Manchester, King Street

Planning update

Planning Permission and Listed Building Consent were received (with conditions) on 7th January 2022 for the proposed scheme.

Updates to the design that are required to meet current regulations and standards, and to future-proof the sustainability of the scheme are as listed below.

Amended Ground Floor Plan Lobby Sketch Proposals

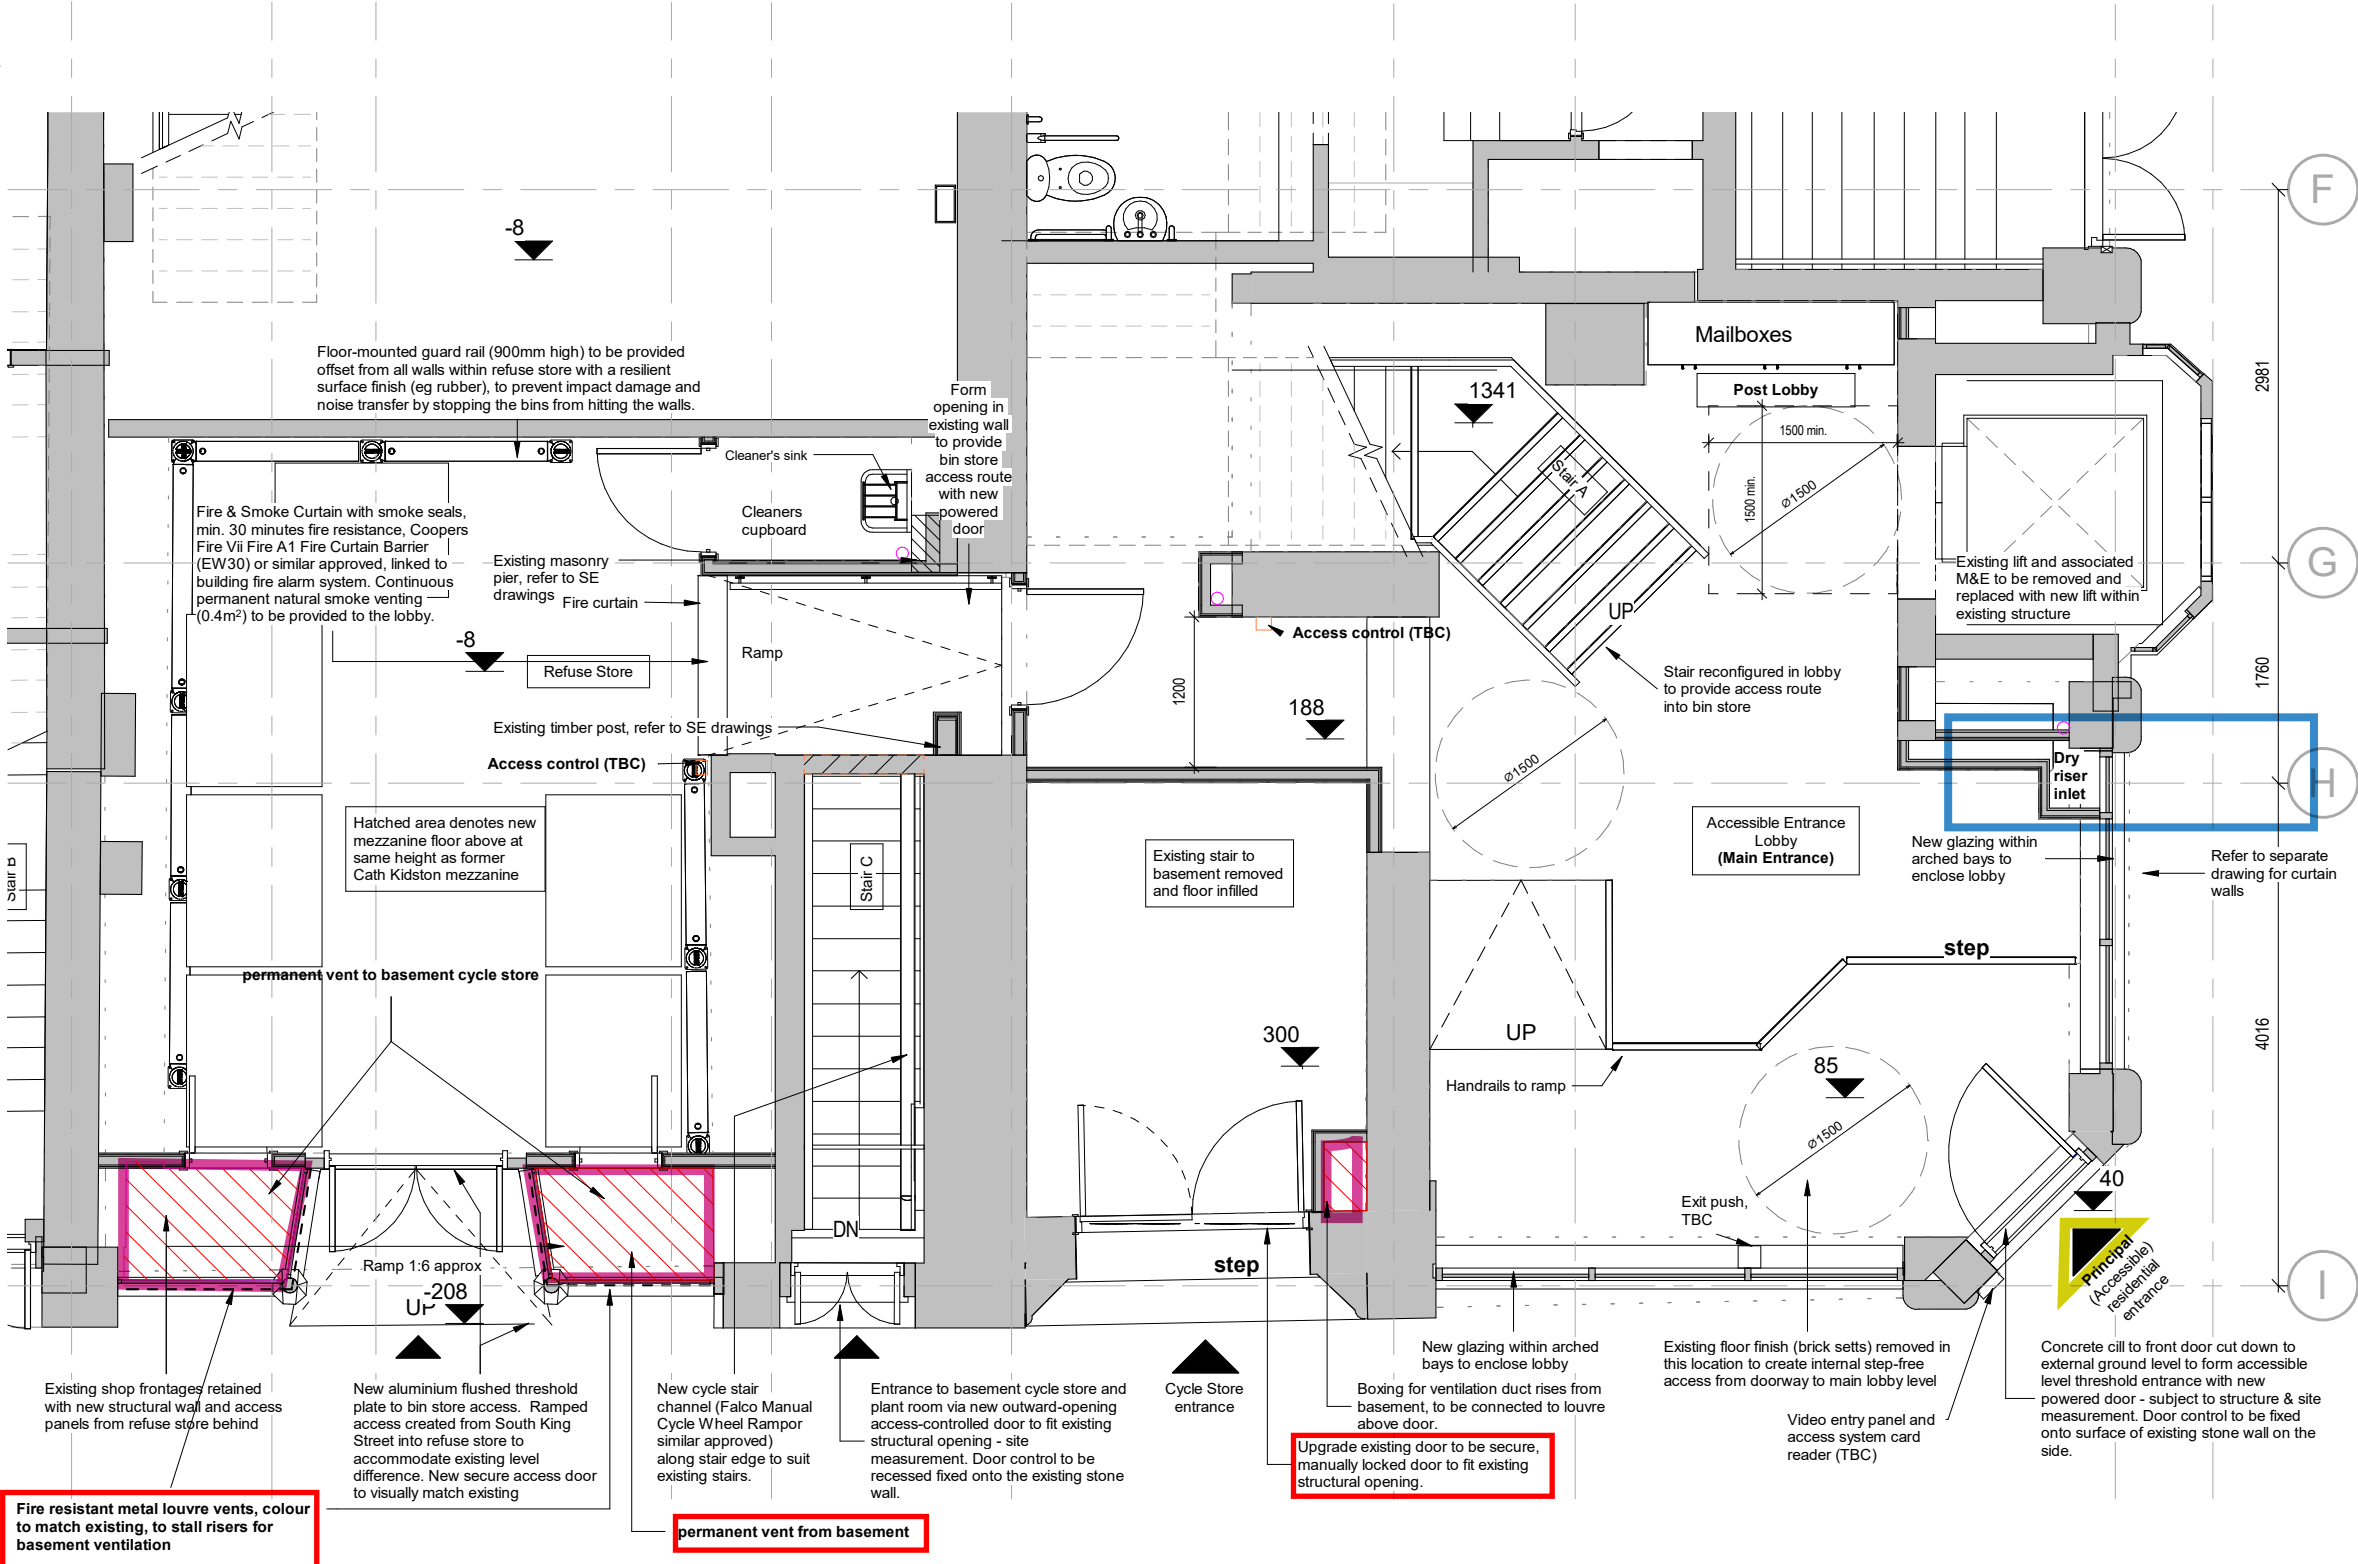
- Main Entrance
- Permanent ventilation required to basement via louvre vents on ground floor elevations.
- Dry riser inlet

Amended Elevation 1 Proposals

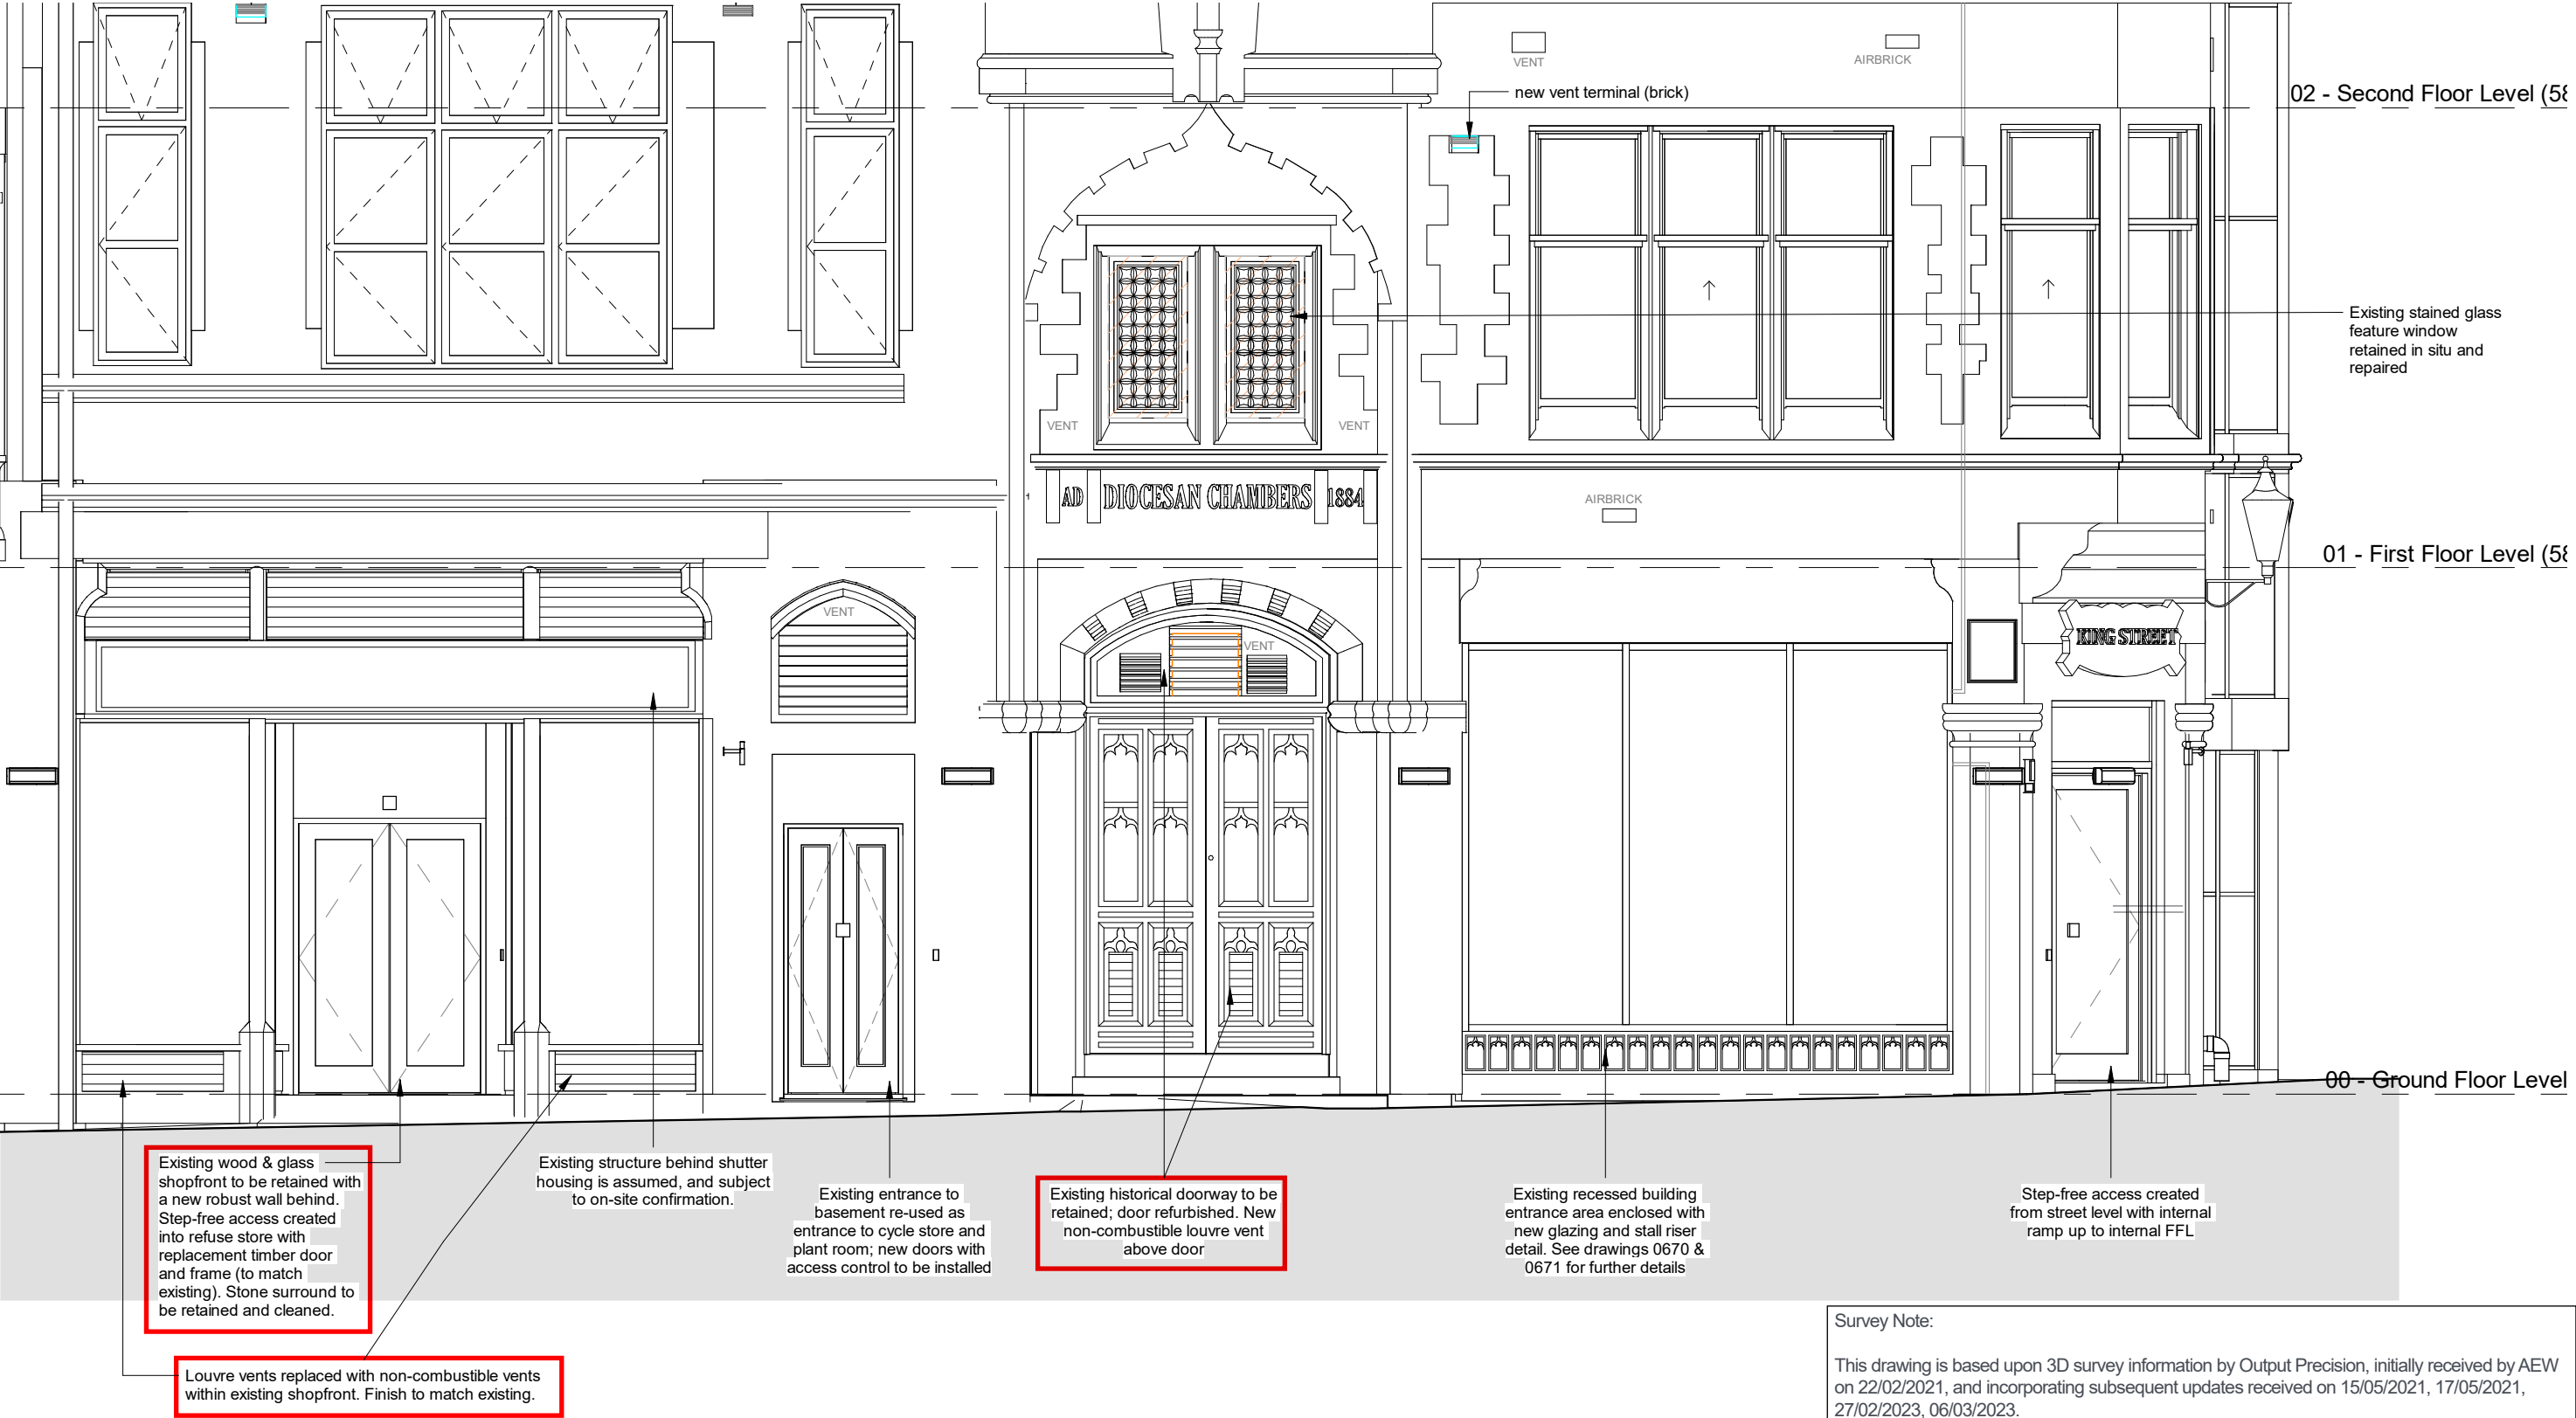
Existing doorway to
basement reused as
entrance to cycle
store; new powered
doors to be installed

Existing historical doorway
to be retained and used as
principal residential
entrance; door refurbished,
new glazing above door

Existing recessed building
entrance area enclosed with
new glazing & stall riser detail

Level access created from
street level with internal
ramp up to internal FFL

Amended Elevation 2 Proposals

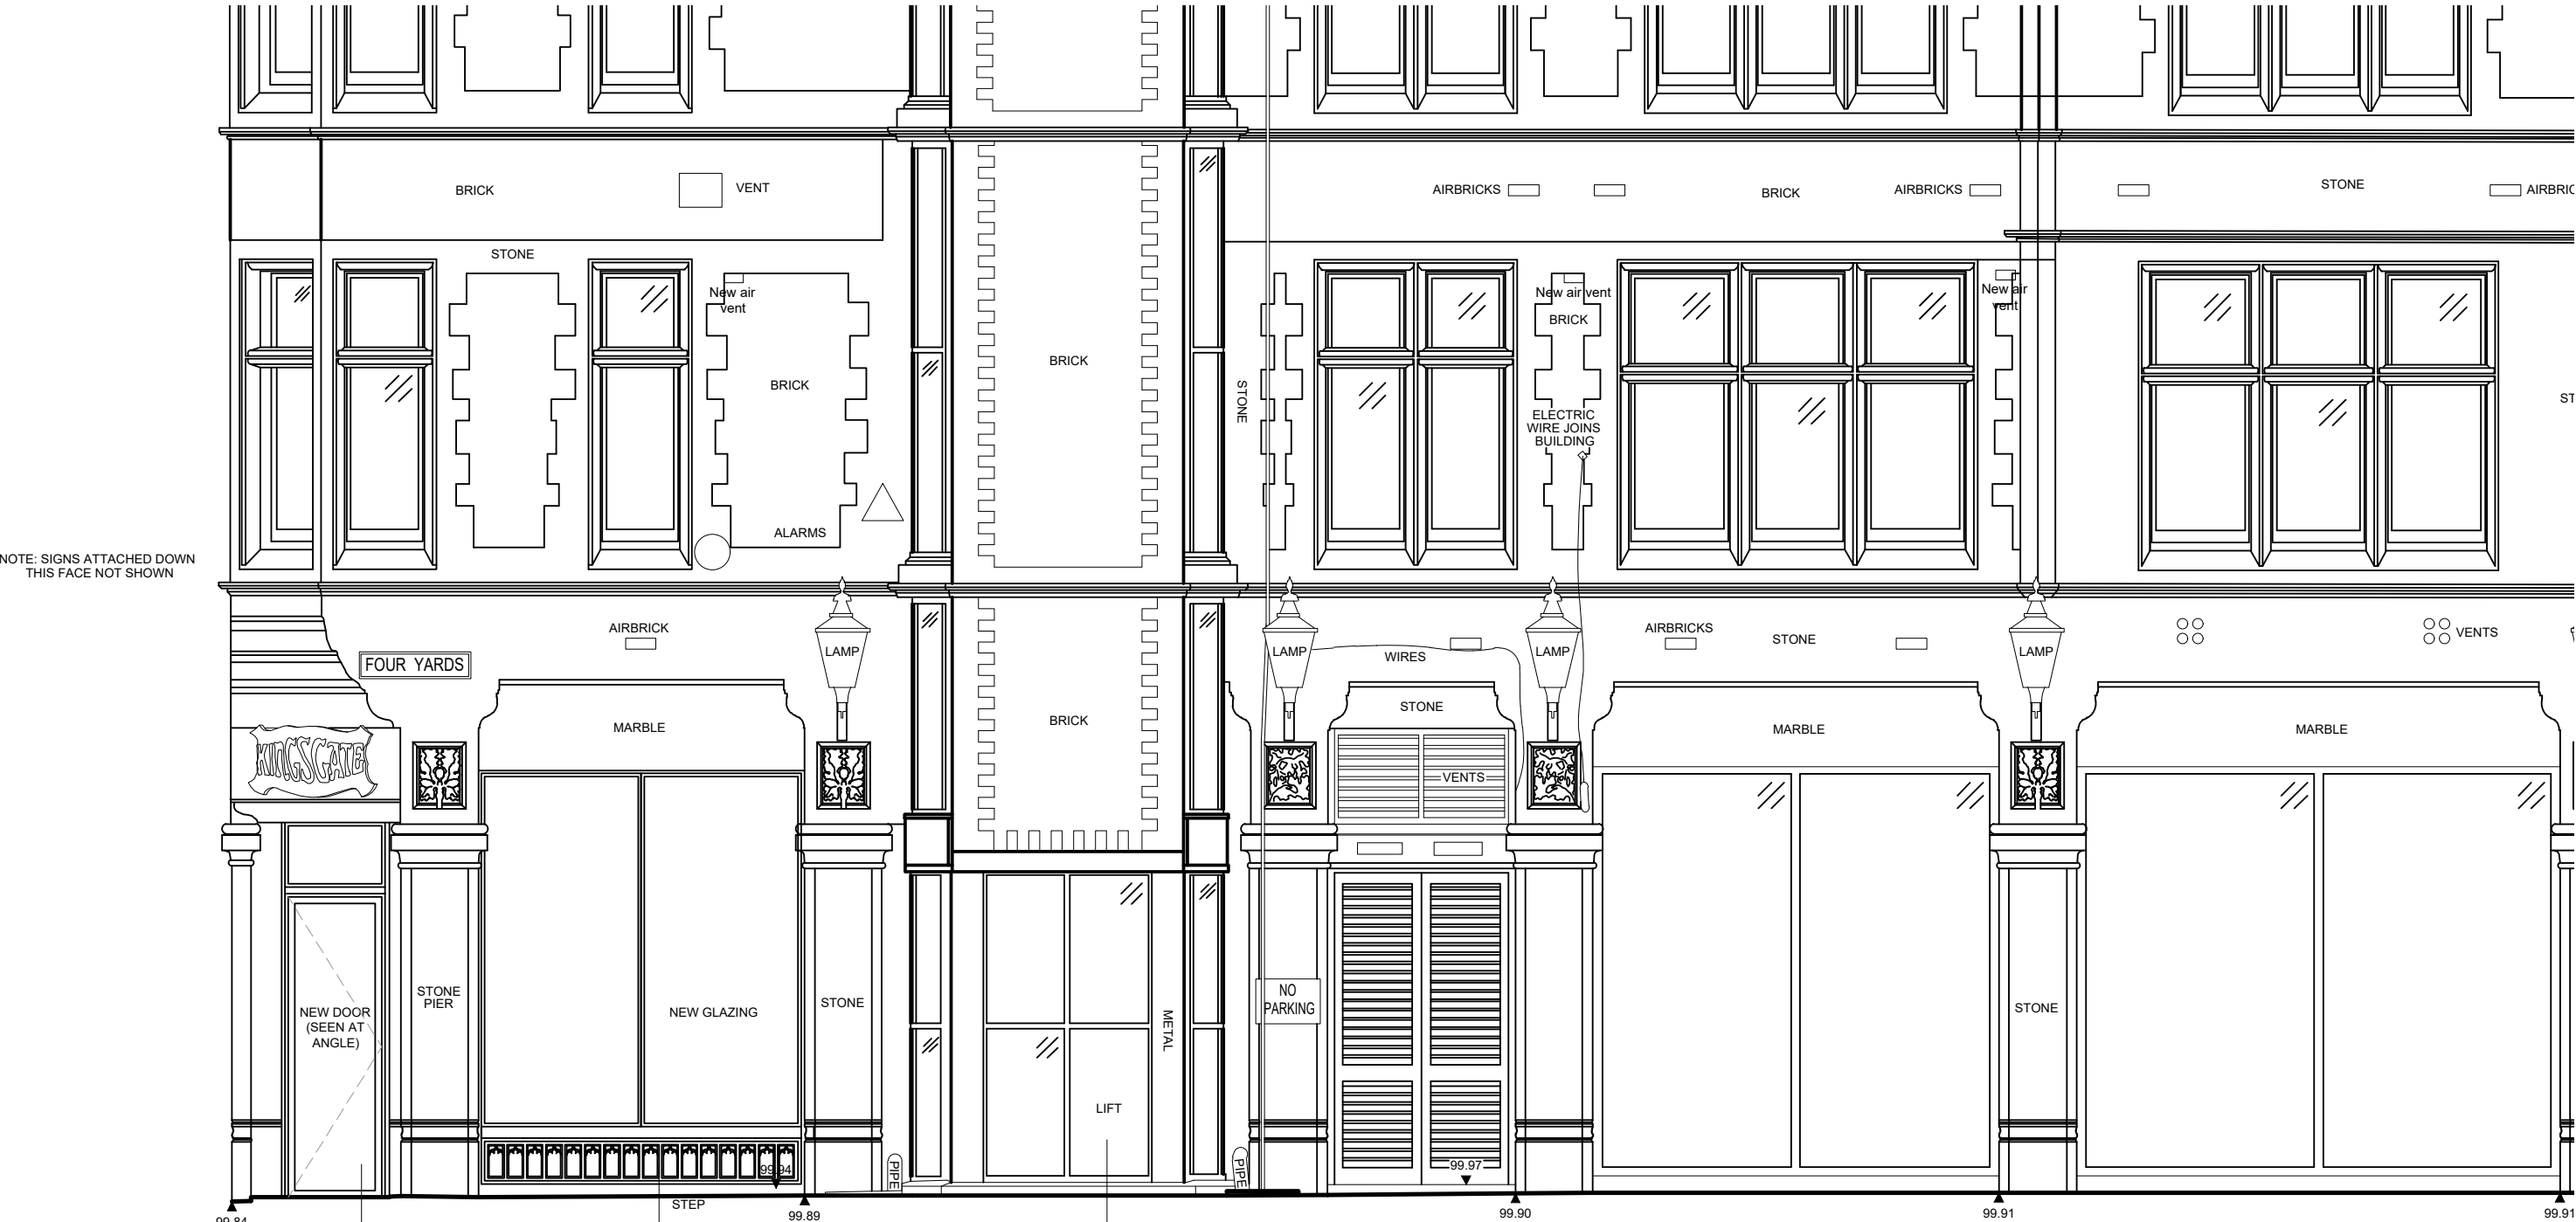
Level access created from street level with internal ramp up to internal FFL

Existing recessed building entrance area enclosed with new glazing & stall riser detail
